## REDTAIL RANCH

### PRELIMINARY PLAN

### LETTER OF INTENT

DECEMBER 2018

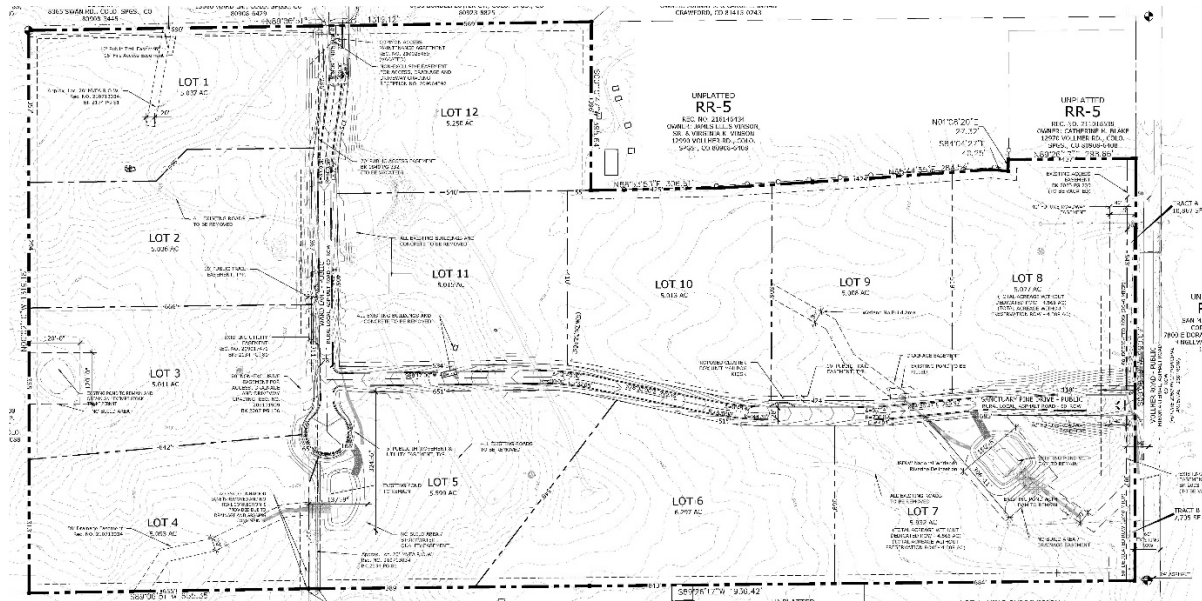
Verify lot area after  
row dedication (not  
easement)

dsdparsons (1)			
	<b>Subject:</b> Callout <b>Page Label:</b> 1 <b>Author:</b> dsdparsons <b>Date:</b> 12/31/2018 1:17:49 PM <b>Color:</b> 	<b>Lot acreage has been verified and reflects the Plat. All lots are a minimum of 5 acres. Lots 7 &amp; 8 are less than 5 acres when excluding the Preservation ROW.</b>	Verify lot area after row dedication (not easement)
dsdrice (2)			
	<b>Subject:</b> Callout <b>Page Label:</b> 5 <b>Author:</b> dsdrice <b>Date:</b> 12/28/2018 2:14:44 PM <b>Color:</b> 	<b>The Ward access easements have been terminated by merger of title and have been removed from the Preliminary Plan and Plat.</b>	Address extinguishing or subordination of existing access easements within proposed Ward Ln. ROW.
<hr/>			
	<b>Subject:</b> Callout <b>Page Label:</b> 2 <b>Author:</b> dsdrice <b>Date:</b> 12/28/2018 4:28:49 PM <b>Color:</b> 	<b>Language has been clarified.</b>	20-foot dedication plus 40-foot preservation easement?
